# SUBSTITUTE LANDSCAPE PLAN

MICAH JEUB  
GLAMPING II  
SITE DEVELOPMENT PLAN

PROJECT NO.	PPR2433	SHEET
DATE	08/14/24	1
PREPARED BY	NRH	APPROVED

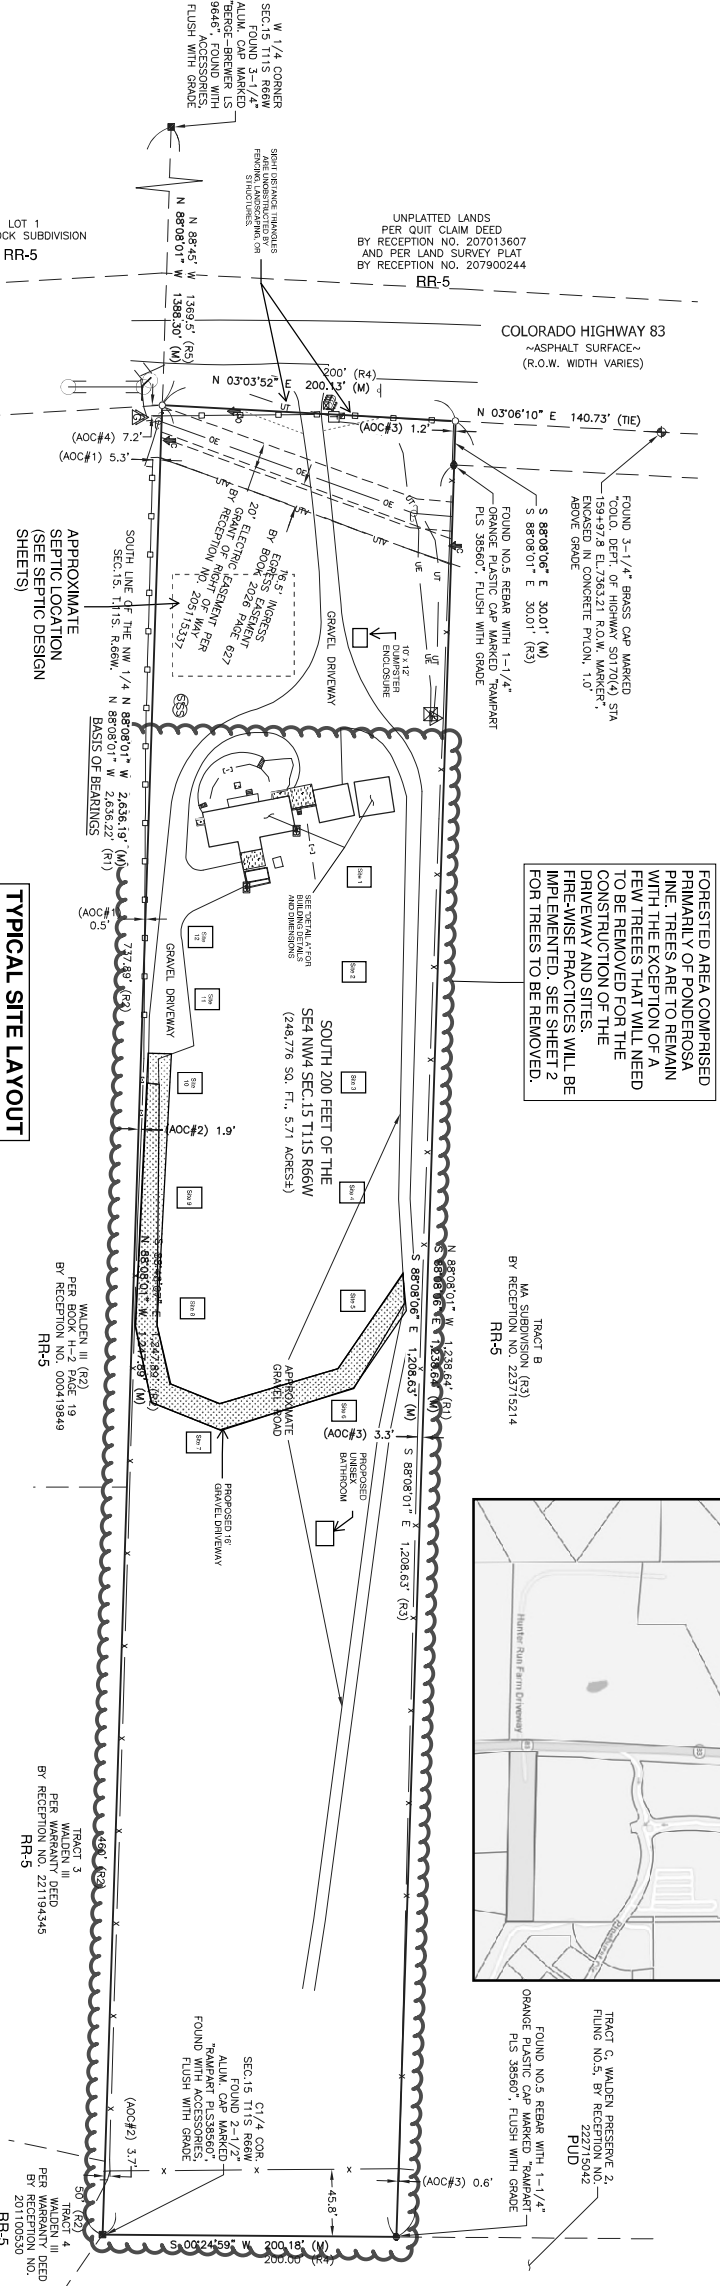
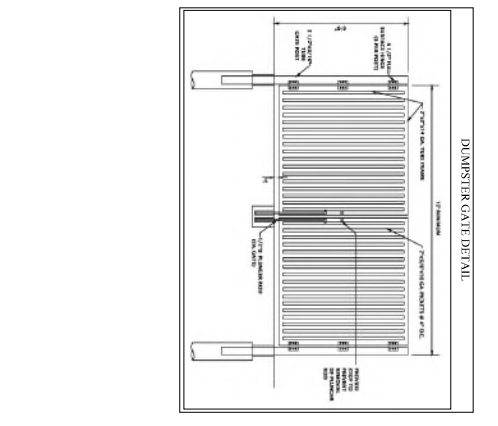
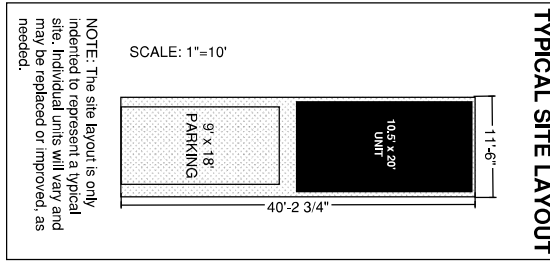
Please make image color and trees to be removed in red
